"Coolant level too low" warning message shown in instrument cluster

Topic number	LI20.30-P-078333
Version	2
Function group	20.30 - Coolant expansion/overflow tank
Date	3/21/25
Validity	Model 243
Reason for change	New expansion reservoir

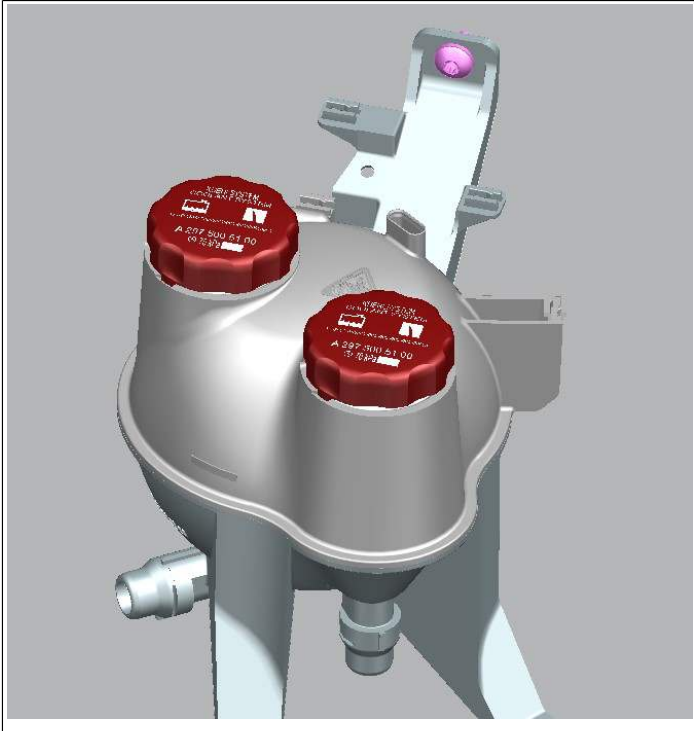
The vehicle's electric drive motor transports air into the cooling system.
The air transported into the cooling system leads to the formation of an air cushion in the expansion reservoir, which in turn causes the coolant level to drop below the warning threshold of the coolant's fill level sensor when driving.
After opening the closing cap, the coolant level is OK again.

Replace the black cap A210 501 06 15 of the large working chamber of the expansion reservoir with a red cap A297 500 51 00

and the coolant level rises by roughly 20 mm above the MAX. marking.

On vehicles in which the problem cannot be rectified by this procedure, the expansion reservoir A 243 500 41 00 is replaced by the modified container A243 500 60 00.

The new expansion reservoir is to have two red closing caps A 297 500 51 00 fitted to it, and the coolant level is to be set to the MAX. marking.
